Access Compliance Report

Public Rights-of-Way

(Curb Ramps)

Intersection ID: 32074	Main Street: SPRINGBANK_LN	Cross Street: SPRINGS_VILLAGE_LN	Location: NW
ADA ID: 5924EA7E8B78	Ramp Type: PerpDiag	Initial Pass/Fail: Fail	Overall Compliance: No
Severity Score: 13.75			
Codes/Mitigation Info/Possible Solution		Field Measurements/Component Compliance

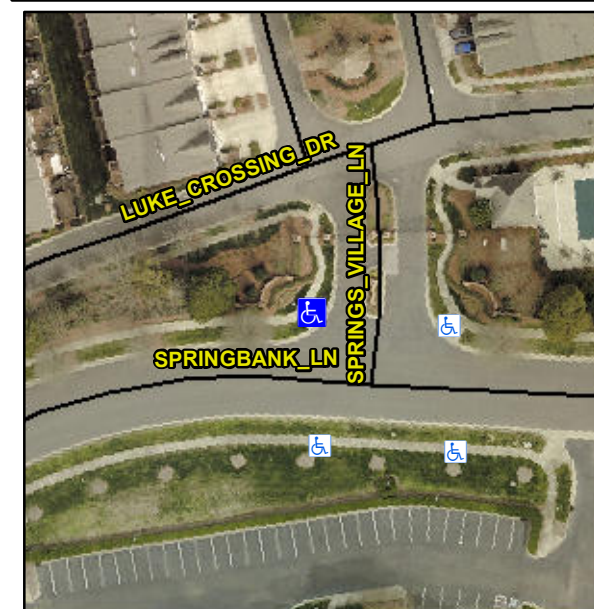
R304.2.2, R304.5.3

Compliance	Description	Data	Compliance	Description	Data
N/A	Ramp Length (in)	96.0	No	Ramp Slope (%)	8.6
Yes	Ramp Width (in)	49.0	No	Ramp XSlope (%)	3.0
N/A	Flare Type LT	N/A	N/A	Flare Type RT	N/A
N/A	Flare Slope LT (%)	N/A	N/A	Flare Slope RT (%)	N/A
N/A	Flare Traversable LT?	N/A	N/A	Flare Traversable RT?	N/A
N/A	Landing Length (in)	N/A	N/A	DWS Provided?	N/A
N/A	Landing Width (in)	N/A	N/A	DWS Contrast?	N/A
N/A	Landing Slope (%)	N/A	N/A	DWS Length (in)	N/A
N/A	Landing X Slope (%)	N/A	N/A	DWS Full Width?	N/A
N/A	Landing Curb? (Y/N)	N/A	N/A	DWS Offset (in)	N/A
N/A	Shared Landing?	N/A			
N/A	Gutter Ponding?	N/A	N/A	Gutter Slope (%)	N/A
N/A	Gutter Lip Ht (in)	N/A	N/A	Gutter X Slope (%)	N/A
N/A	Painted X Walk1?	No	N/A	Painted X Walk2?	No
	X Walk 1 Direction	To S		X Walk 2 Direction	To SE
N/A	X Walk 1 Width (in)	N/A	N/A	X Walk 2 Width (in)	N/A
	X Walk 1 Slope (%)	6.1		X Walk 2 Slope (%)	0.4
	X Walk 1 X Slope (%)	1.3		X Walk 2 X Slope (%)	4.9

N/A	Ramp inside XWalk1?	N/A	N/A	Ramp inside XWalk2?	N/A
	Road Slope (%)	3.6	N/A	Clear Space?	N/A
	Road X Slope (%)	4.1	N/A	Clear Space to XWalk (in)	N/A
N/A	Any Obstructions?	N/A	N/A	Storm Grate/Utility Hazard?	N/A
	Obstruction Type			Storm Grate/Utility Type	
		N/A			N/A
		Yes		Surface Condition? (G/P)	Good

Remove & Replace Curb Ramp With Two New Directional Ramps or Equivalent.
